UNITED STATES PATENT AND TRADEMARK OFFICE

10/550,802

Office Action Summary	Application No. 10/550,802	Applicant(s) SUZUKI ET AL.	
	Examiner NAHID AMIRI	Art Unit 3679

DETAILED ACTION

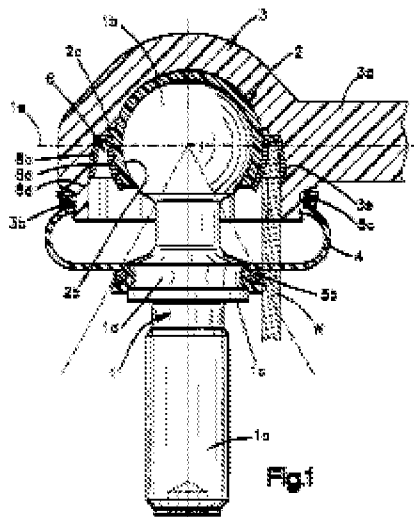
With respect to claim 1, Dorr discloses a ball joint (Fig. 1) comprising a housing (3) with an opening portion; a ball head portion (2) rotatably housed in said housing (3); a ball stud (1) comprising: a stud portion (1a) provided in a protruding manner from said ball head portion (2), and protruding from said opening portion; and a brim portion (1d) provided in a protruding manner on an outside surface of said stud portion (1a); and an elastic approximately pipe-

formed dust cover (4) inserted through said stud portion (1), provided across an outside surface of said housing (3) and an outside surface of said stud portion (1) so as to block said opening portion, said dust cover (4) comprising a first lip portion (constituted by a right curved end portion of the dust cover 4) closely fitted in a manner urged toward a ball head portion-side end face of said brim portion; and a second lip portion (constituted by a left curved end portion of the dust cover 4) which is closely fitted in a manner urged toward an outside surface of said brim portion (1d).

With respect to claims 2 and 3, Dorr discloses (Fig.1) that the first lip portion is urged toward a ball head portion-side end face of said brim portion (1d), and closely fitted to a part of said end face; and wherein second lip portion is urged toward an outside surface of the brim portion (1d), and closely fitted to a part of said outside surface.

With respect to claim 4, Dorr discloses (Fig.1) that the dust cover (4) is provided with a pocket portion (constituted by U-shaped between said first lip portion, said second lip portion and said brim portion (1d) of said ball stud (1), retaining a lubricant member (5b) inside.

With respect to claim 5, Dorr discloses (Fig.1) that the second lip portion is urged toward an outside surface of the brim portion (1), and closely fitted to a part of said outside surface.

With respect to claim 6, Dorr discloses (Fig.1) that the dust cover (4) is provided with a pocket portion between said first lip portion and said second lip portion and said brim portion (1d) of said ball stud (1), retaining a lubricant member inside (5b).

With respect to claim 7, Dorr discloses (Fig.1) that dust cover is provided with a pocket portion between said first lip portion, said second lip portion and said brim portion (1d) of said ball stud (1), retaining a lubricant member inside (5b).

With respect to claim 8, Dorr discloses (Fig.1) that the dust cover is provided with a pocket portion between said first lip portion, said second lip portion and said brim portion (1d) of said ball stud (1), retaining a lubricant member inside (5b).

FIG. 1

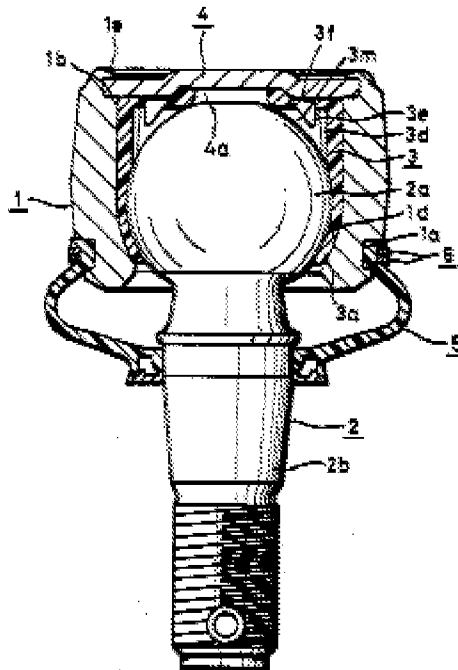
With respect to claim 9, Dorr discloses fails to disclose that the opening portion is located on one end of the housing, and the opposite end of the housing is closed by a plug caulked to the housing (3). Fukukawa et al. disclose a ball joint (Fig. 1) having an opening portion is located on one end of the housing (3), and the opposite end of the housing (3) is closed by a plug (4) caulked to the housing (3). It would have been obvious to one of ordinary skill in the art at the time of invention was made to provide the housing of Dorr with a plug as taught by Fukukawa et. al. in order to seal the top portion of the housing.
